## Chapter 4: Mining Background and Mining Scenario

In late May 2012 EPA published for public comment, an assessment of the Bristol Bay watershed and southwest Alaska. The document is intended to help EPA understand how future large-scale mining may affect the Bay's valuable fishery resources, particularly its salmon fishery. It is titled *Assessment of the Potential Mining Impacts on Salmon Ecosystems of Bristol Bay, Alaska*.

Of the 5,522<sup>1</sup> on-time comments postmarked by July 23, 2012, a total of 319 letters were submitted by commenters other than the general public, 2,177 comments were submitted by individuals from the general public, and 29 mass mailing campaigns were sponsored by a number of organizations. The remaining letters are from mass mailing campaigns. In addition, EPA held eight public hearings, for which transcripts were developed. This document provides a compendium of the technical comments related to mining background and the mining scenario.

**Figure 1. Comparison of Milling Rate for Mines in Alaska/BC & EPA's Hypothetical Mine<sup>13</sup>**

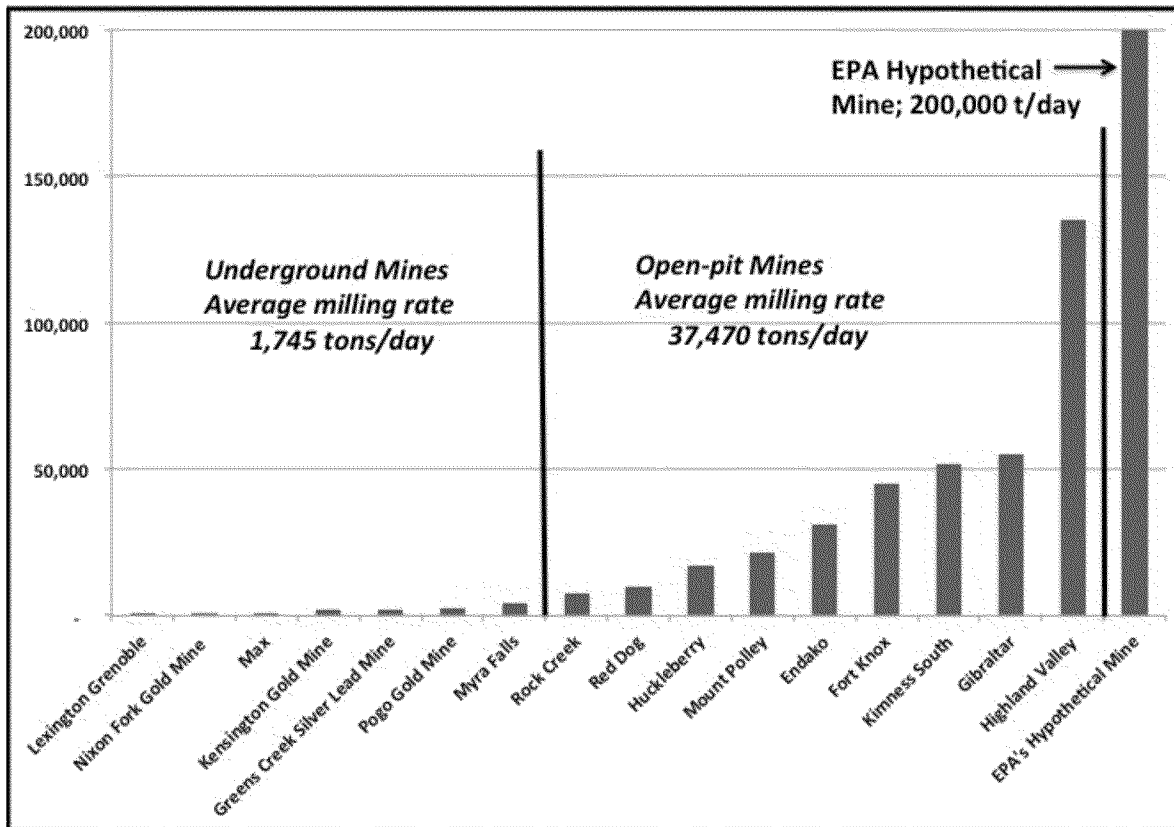
Figure 1 shows the milling rate for mines in British Columbia and Alaska. (Appendix A explains the data sources for the figure). The figure shows that the Assessment's hypothetical mine is much larger than any mine in Alaska or British Columbia. In fact, the average open-pit mine in the two areas mills an average of 37,470 tons/day. EPA's hypothetical mine assumes 200,000 tons/day, which is more than is five times larger than this average.

British Columbia includes five open-pit mines where Copper is the major or one of the major target minerals. The average milling rate for those mines is 56,120 tons/day. The EPA's hypothetical mine is almost four times that amount.

While it is not possible to estimate the mine size for a ore body that has not yet been discovered, a comparison of mines in British Columbia and Alaska show that the EPA's hypothetical mine almost certainly is a gross overestimate of the likely size for any other yet to be discovered project. (Doc. #4612.2, p. 16).
